RE: **Response to Riverside County Review Comments dated
December 5, 2018** - Proposed Warehouse Development - Located
at the Southeast Corner of Perry Street and Seaton Avenue, Mead
Valley, in the County of Riverside, California

County Geologic Report No. 180039

"Geotechnical Investigation, Proposed Warehouse Development, Southeast Corner Perry Street and Seaton Avenue, Mead Valley, County of Riverside, California," dated July 23, 2018.

REGIONAL GEOLOGIC MAP

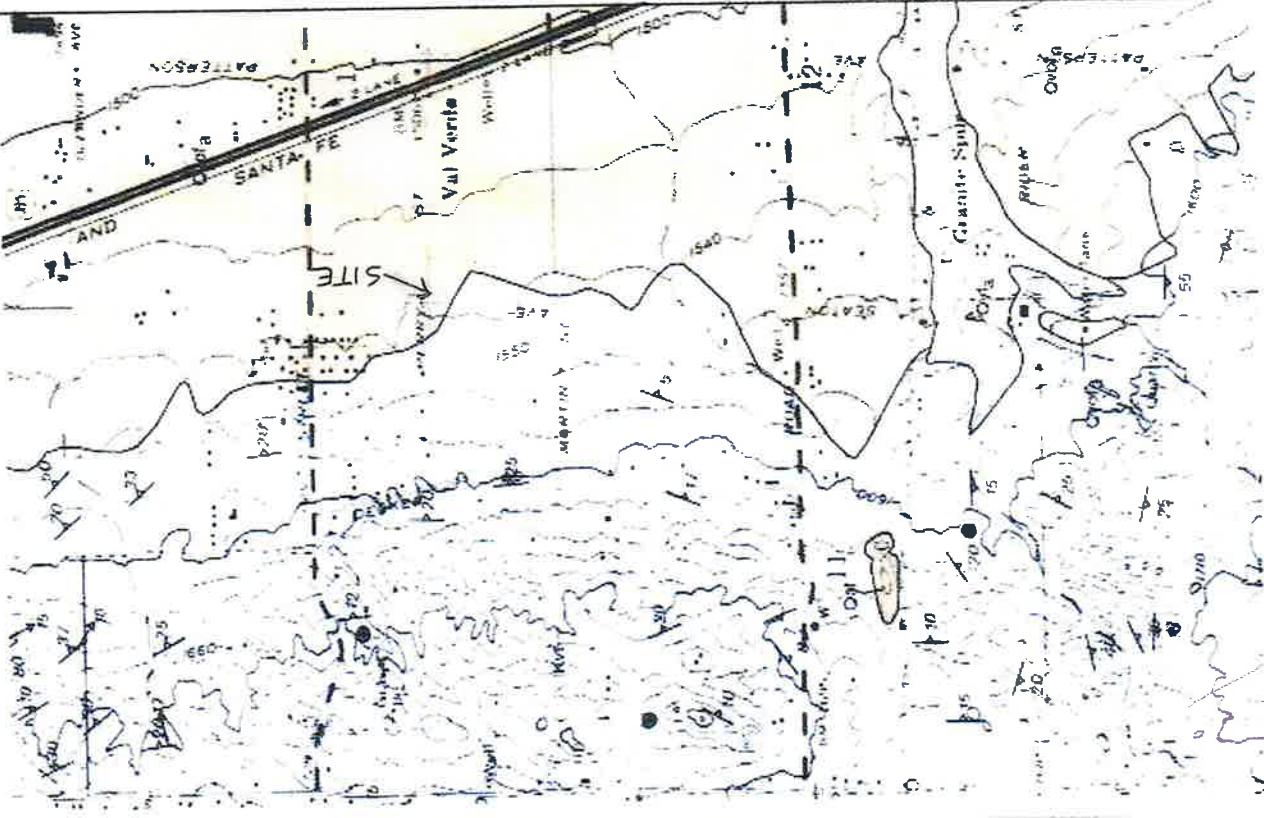
5. Please provide a geologic map with north arrow, a minimum scale of (1in:2,000 ft.), legend, and reference indication.
6. Please provide an estimation of age for the "Natural Soils" encountered the exploratory trenches.

A Regional Geologic Map is attached to this response report.
